Appl'n No. 10/694,745 Amdt Dated July 6, 2004 Reply to Office Action Dated Apr. 6, 2004 Annotated Sheet Showing Changes (1 of 2) FIG. 3A PRIOR ART __ 33 FIG. 3B PRIOR ART FIG. 3C PRIOR ART ₂₃ 2,9 PRIOR ART FIG. 3E PRIOR ART

Appl'n No. 10/694,745 Amdt Dated July 6, 2004 Reply to Office Action Dated Apr. 6, 2004 Annotated Sheet Showing Changes (2 of 2)

FIG. 5D 7

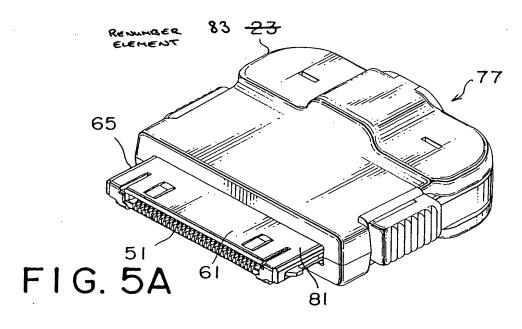
RENUMBER FIGURE
